Stantec Architecture Ltd.
 202-107 Main Street, Whitehorse YT Y1A 2A7
 Phone: (867) 633-2400

File: Polaris Project
 Addendum No: 01
 Date: November 21, 2024
 Owner: Yukon University
 Contract No. 144214760

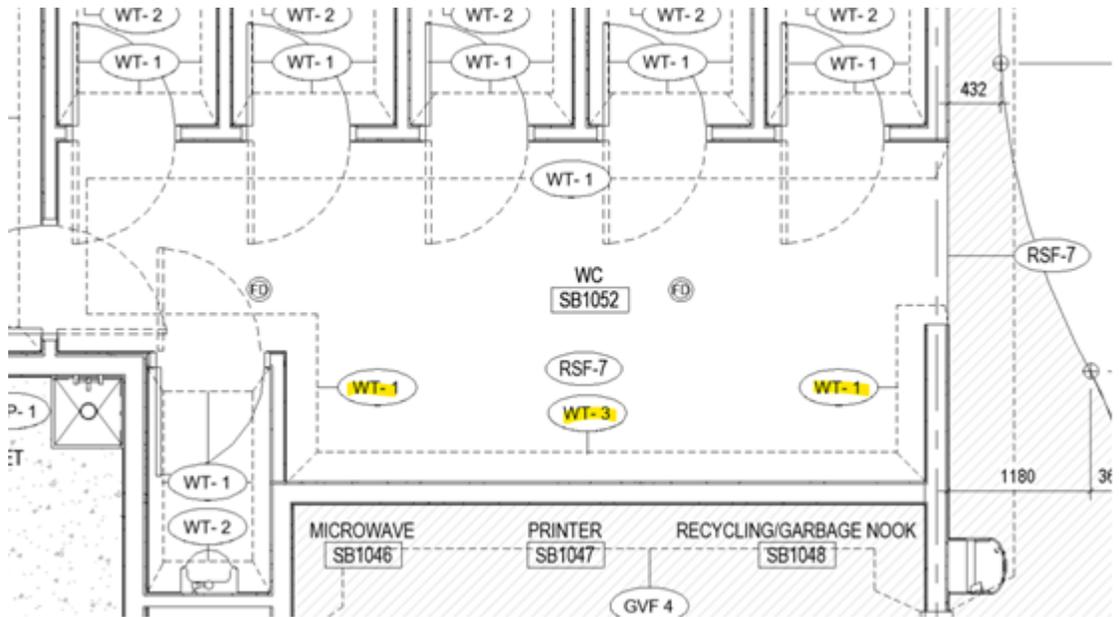
- 1.1 *Drawing A420 – Enlarged Finishes Plan – Zone 1: Updated Wall Tile WT-3 to only be on sink wall, Side walls to be WT-1 for rooms WC SB1015 & WC SB1013.*

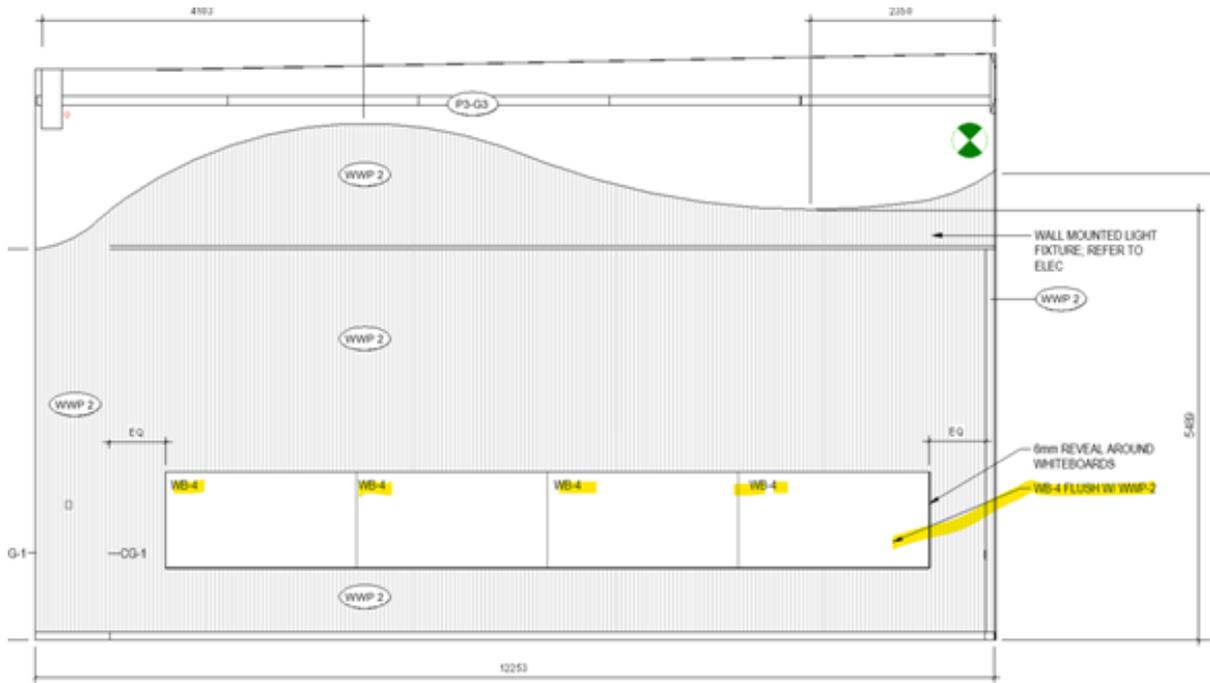
- 1.2 *Drawing A422 – Enlarged Finishes Plan – Zone 3: Updated Wall Tile WT-3 to only be on sink wall, Side walls to be WT-1 for rooms WC SB1052.*

5 LOUNGE/ EVENT SPACE- NORTH

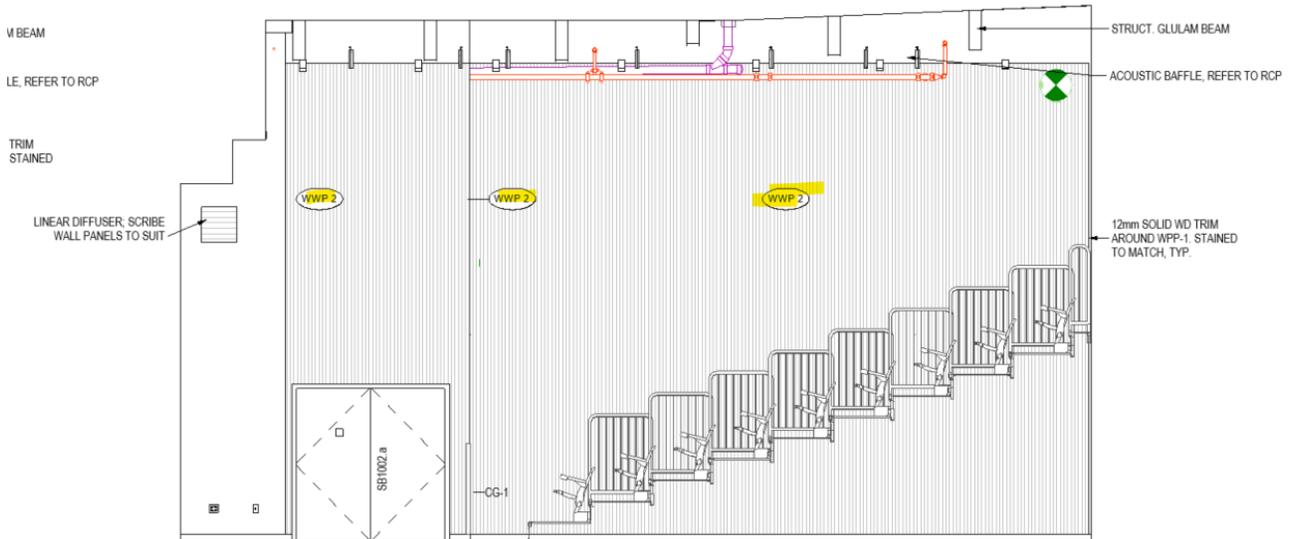
1.3 Drawing A520 – Interior Elevations: 5/A520, updated elevation with WB-4 whiteboards and added note that indicates the whiteboards to be flush with wood wall panel WWP-2.

2 LECTURE HALL - WEST
A520 1:50

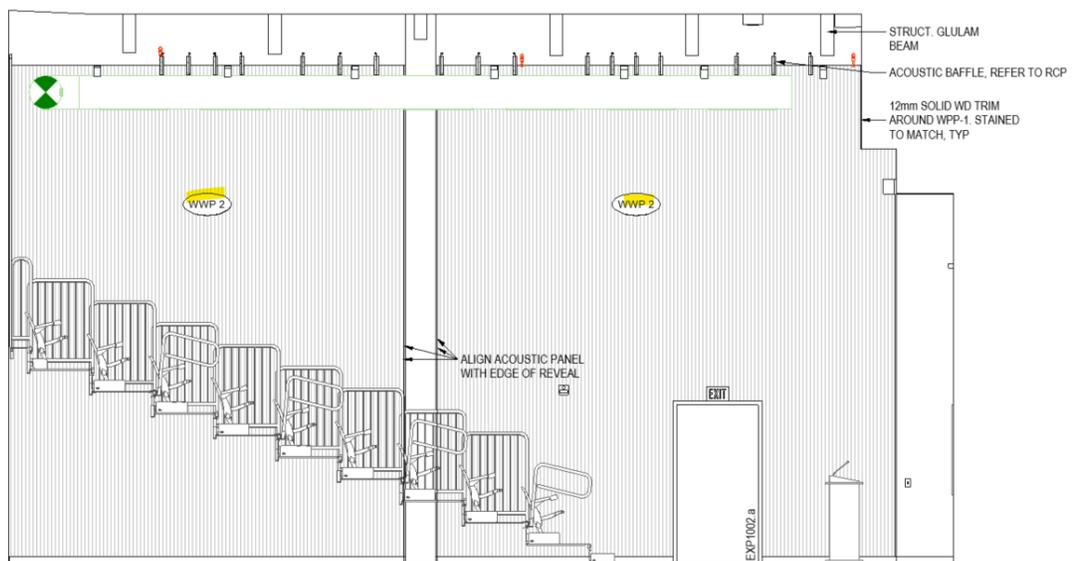
- 1.4 *Drawing A520 – Interior Elevations: 2/A520, updated WWP-2 to extend down and butt against covered base.*

3 LECTURE HALL- EAST
A520 1:50

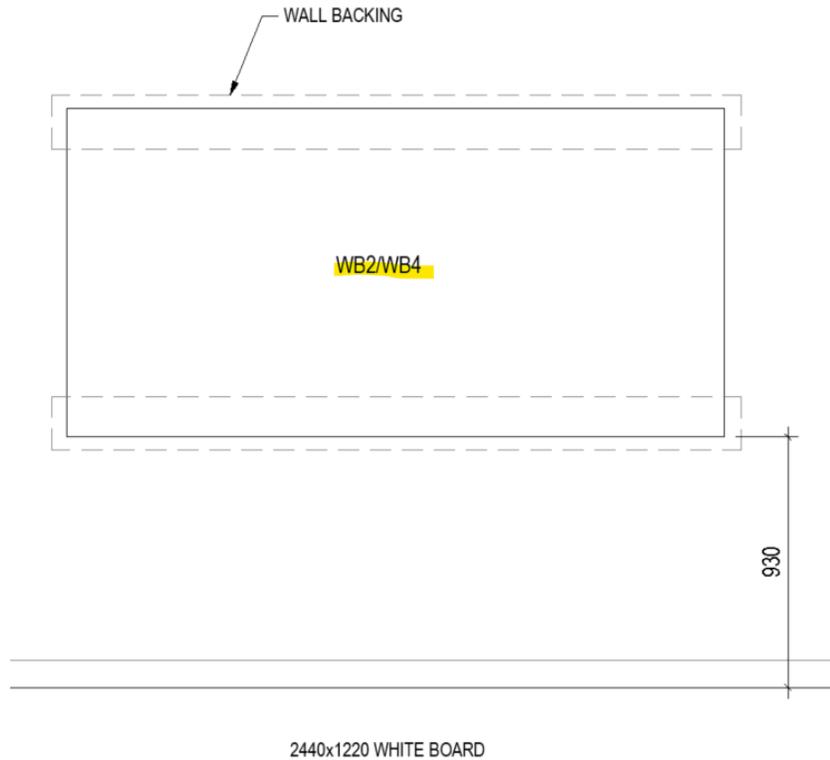
- 1.5 *Drawing A520 – Interior Elevations: 3/A520, updated WWP-2 to extend down and butt against covered base*
